STATEMENT OF ENVIRONMENTAL EFFECTS

**SECTION 4.55 Modifications involving minimal
environmental impact, of the Environmental Planning
and Assessment Act 1979
(Minor Changes to the External Wall Finishes)**

**Demolition of all existing structures, Torrens Title
Subdivision into 2 proposed lots, Construction of a Two-
Storey Attached Dual Occupancy Dwelling and Pools,
External Wall Finishes Changes under S4.55**

@ 5 SEWELL AVENUE, PADSTOW HEIGHTS

Elevations Amendments:

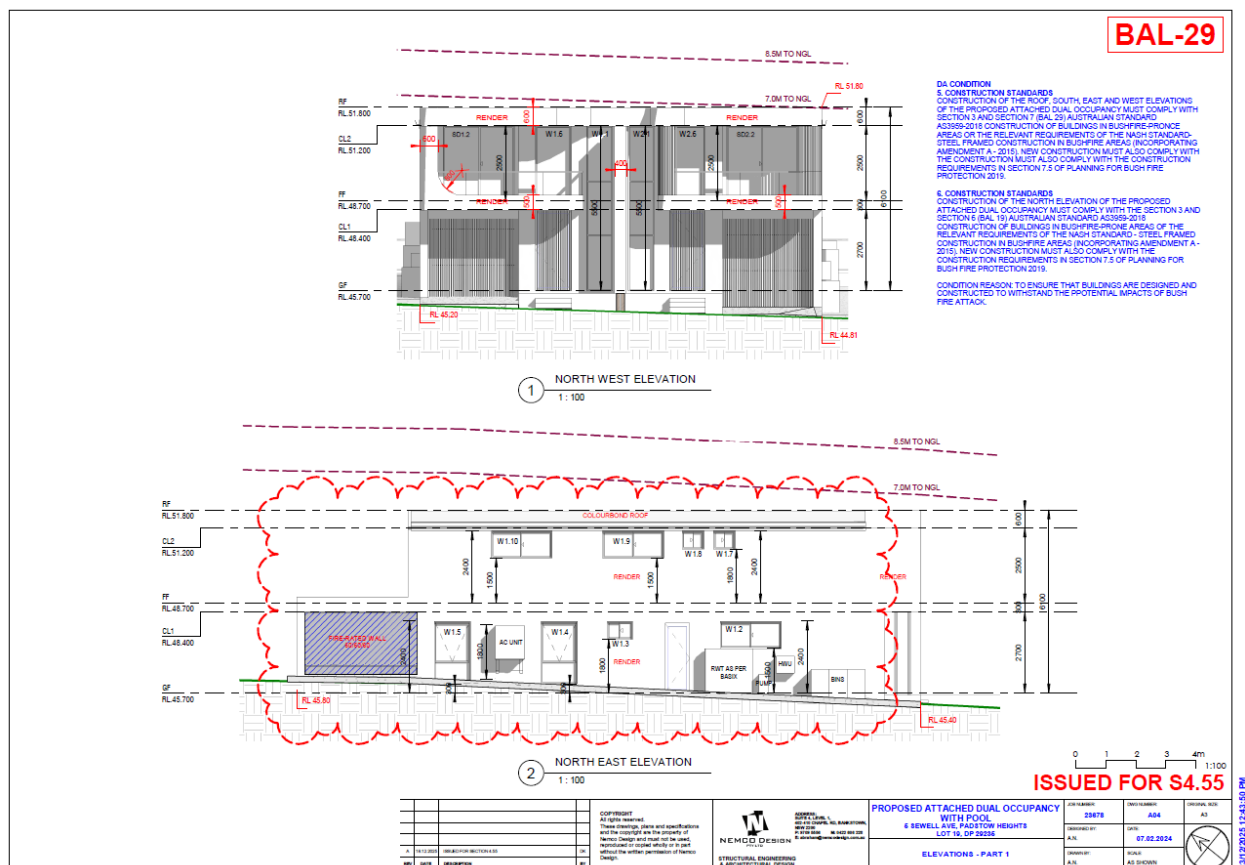
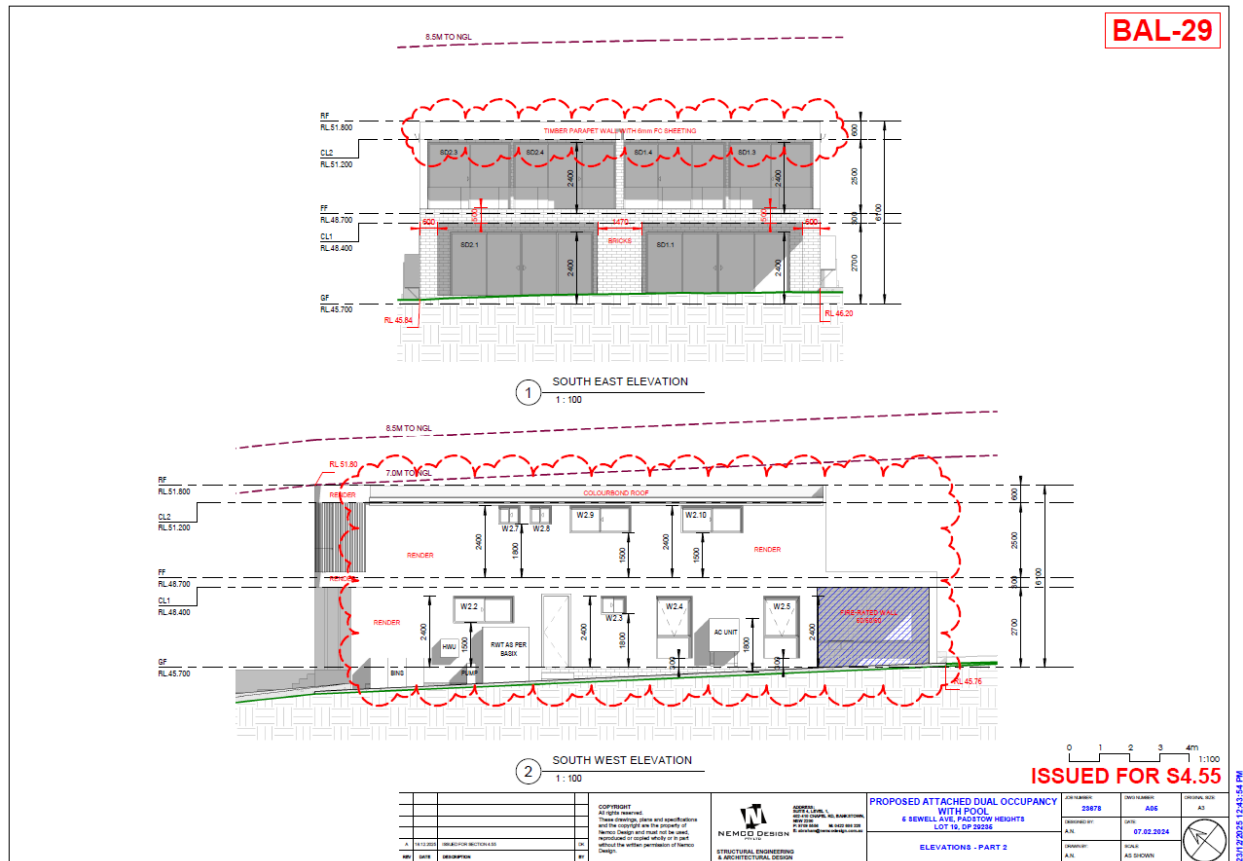
- External wall brick finishes have been amended to rendered wall finishes on the south-west and north-east elevations, with partial application to the south-east elevation.
